REMARKS

Appl. No. 10/662,267
Amdt. Dated August 5, 2004
Reply to Office Action
Annotated Sheet

Fig. 3

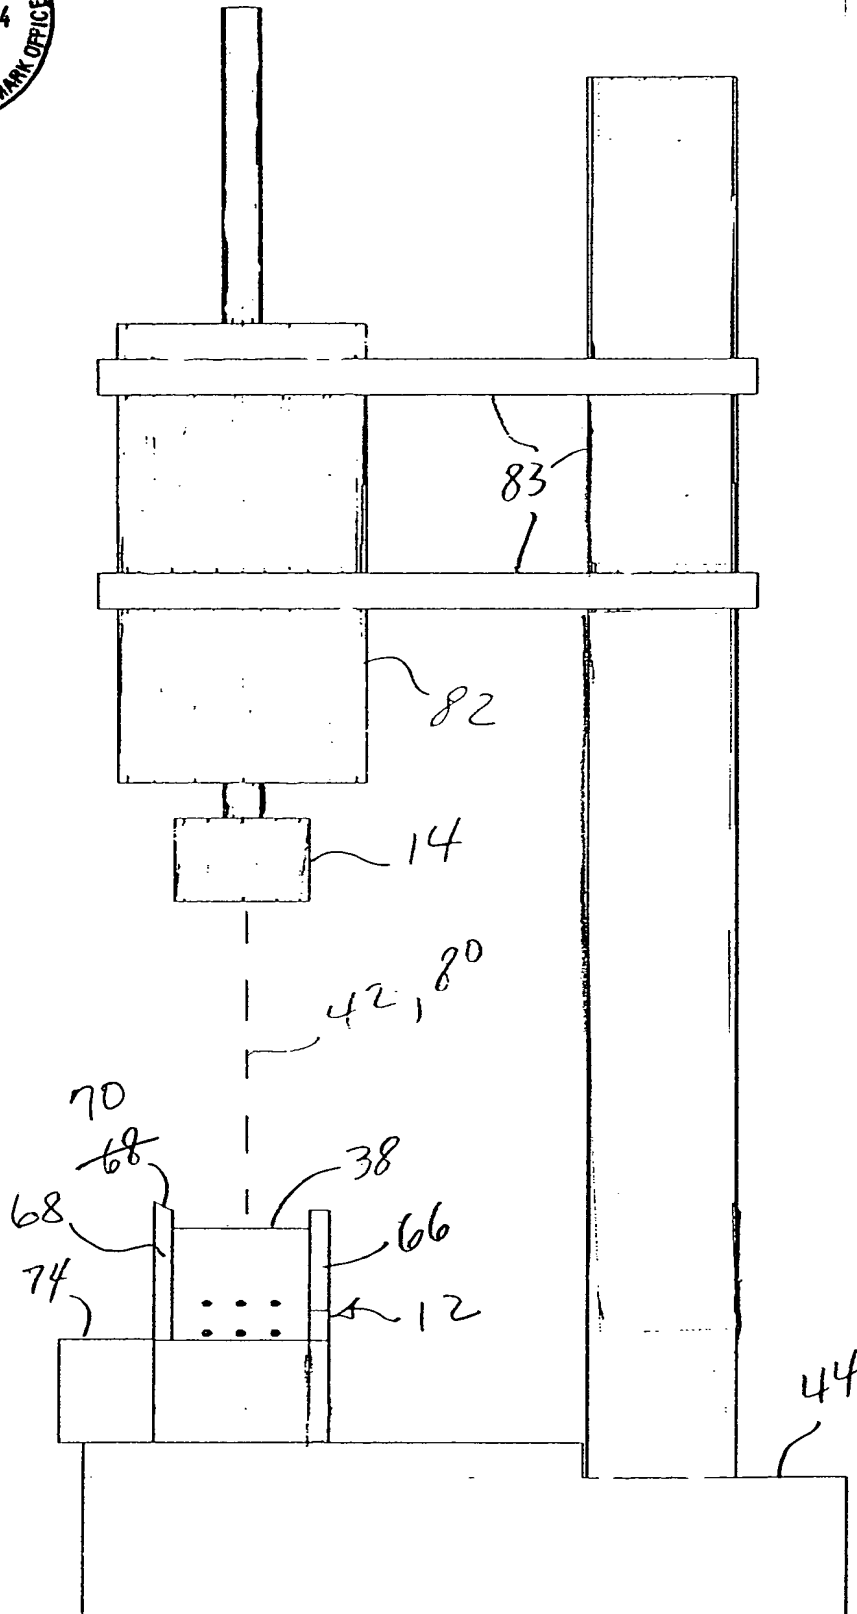
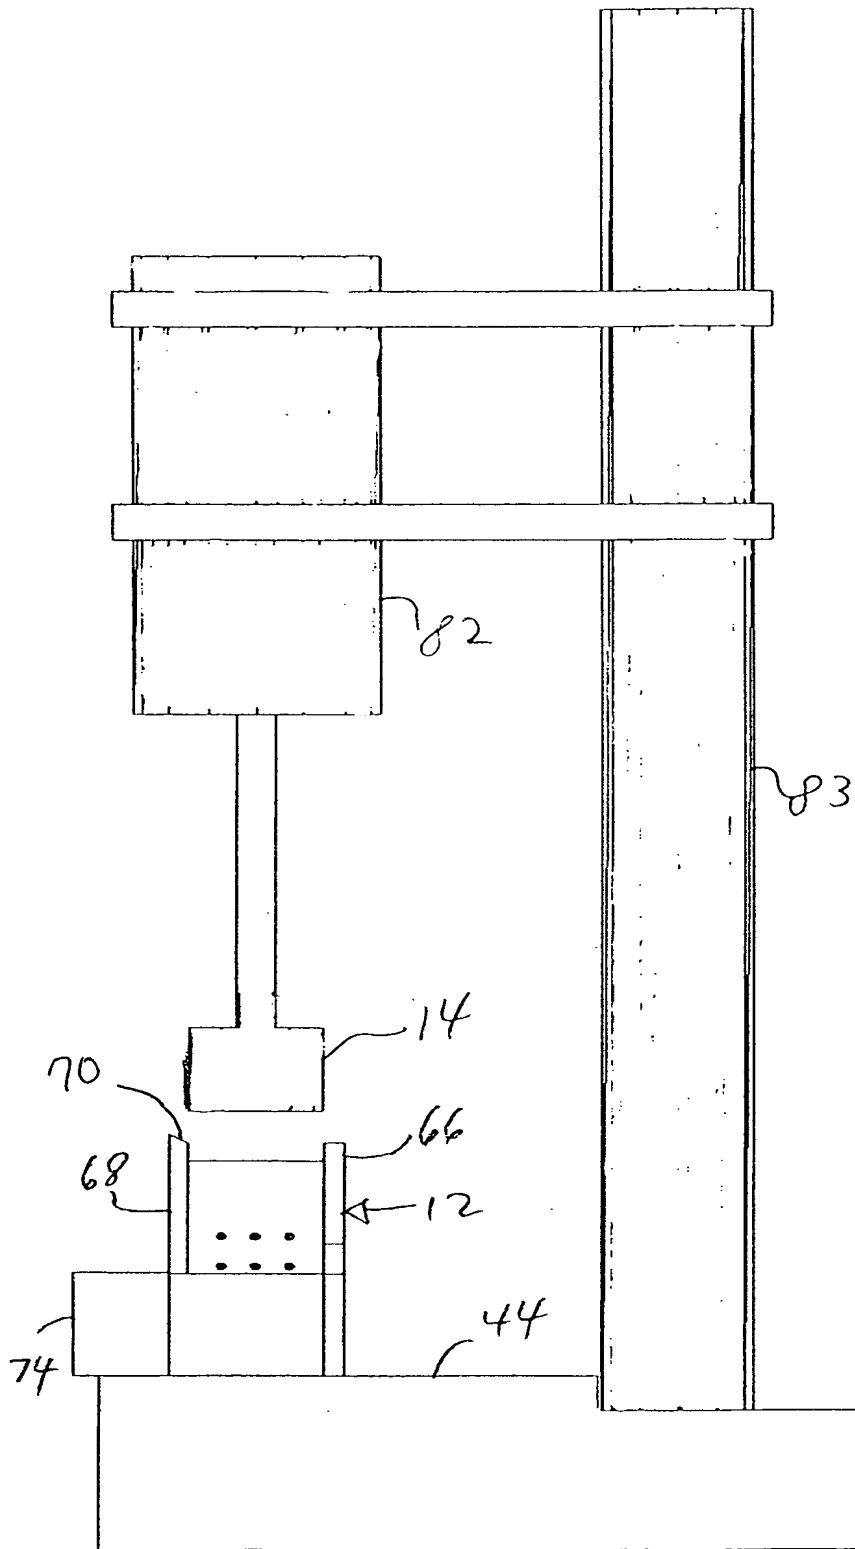
The rejection of Claims 15-33 under 35-USC-112, first paragraph, has been noted. Applicant's attorney has carefully reviewed the disclosure and has amended Figs. 3-5 by placing reference numerals in correct correlation to the description set forth in the original specification. In so doing, there is now a clear description of the invention that is more than sufficient to enable one of ordinary skill in the art to practice the invention. Applicant's attorney regrets the confusion caused by the reference numerals as filed, and submits that no new material has been added.

Fig. 8

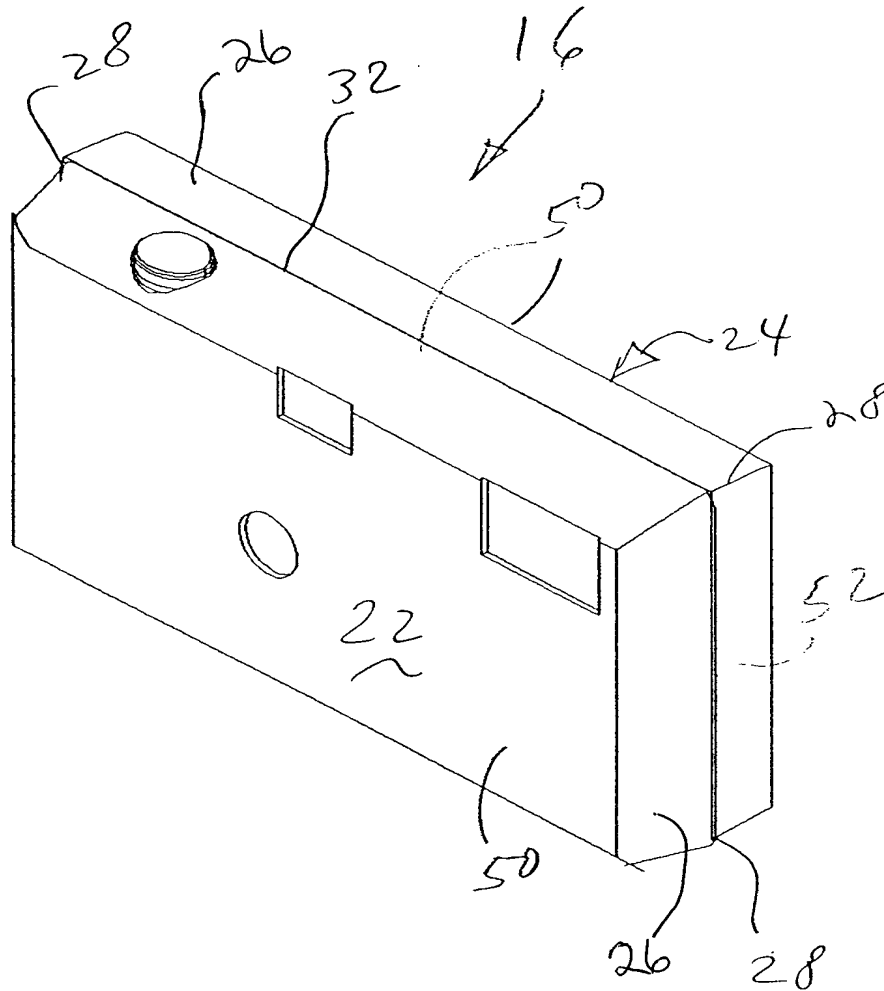
The Examiner's objection to the Drawing has been noted, and the missing reference numeral "26" has been added to FIG. 8. No new matter is added.
